# Access Compliance Report

## Public Rights-of-Way

### (Curb Ramps)

Intersection ID: 13156	Main Street: S_TRYON_ST	Cross Street: W_CARSON_BV	Location: NE
ADA ID: 532726060E9D	Ramp Type: Perp	Initial Pass/Fail: Fail	Overall Compliance: No
Severity Score: 12.5			
Codes/Mitigation Info/Possible Solution		Field Measurements/Component Compliance

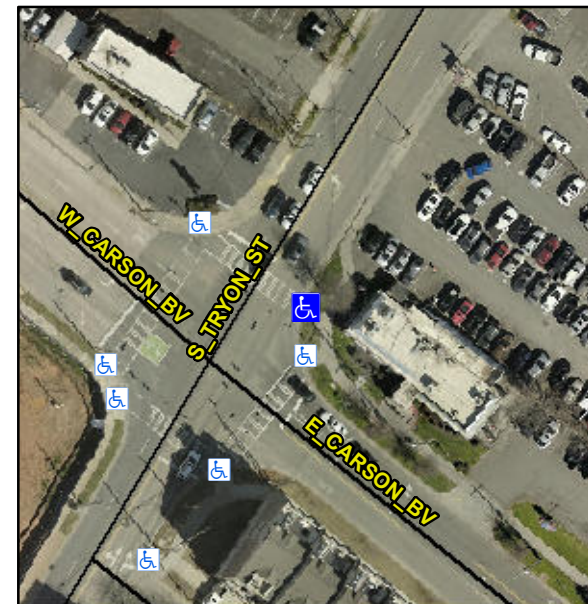
**R304.5.3**

Compliance	Description	Data	Compliance	Description	Data
N/A	Ramp Length (in)	112.0	Yes	Ramp Slope (%)	6.3
Yes	Ramp Width (in)	71.0	No	Ramp XSlope (%)	5.4
N/A	Flare Type LT	N/A	N/A	Flare Type RT	N/A
N/A	Flare Slope LT (%)	N/A	N/A	Flare Slope RT (%)	N/A
N/A	Flare Traversable LT?	N/A	N/A	Flare Traversable RT?	N/A
N/A	Landing Length (in)	N/A	N/A	DWS Provided?	N/A
N/A	Landing Width (in)	N/A	N/A	DWS Contrast?	N/A
N/A	Landing Slope (%)	N/A	N/A	DWS Length (in)	N/A
N/A	Landing X Slope (%)	N/A	N/A	DWS Full Width?	N/A
N/A	Landing Curb? (Y/N)	N/A	N/A	DWS Offset (in)	N/A
N/A	Shared Landing?	N/A			
N/A	Gutter Ponding?	N/A	N/A	Gutter Slope (%)	N/A
N/A	Gutter Lip Ht (in)	N/A	N/A	Gutter X Slope (%)	N/A
N/A	Painted X Walk1?	Yes	N/A	Painted X Walk2?	N/A
	X Walk 1 Direction	To NW		X Walk 2 Direction	N/A
N/A	X Walk 1 Width (in)	113.0	N/A	X Walk 2 Width (in)	N/A
	X Walk 1 Slope (%)	5.2		X Walk 2 Slope (%)	N/A
	X Walk 1 X Slope (%)	1.3		X Walk 2 X Slope (%)	N/A

**Remove & Replace Entire Ramp.**
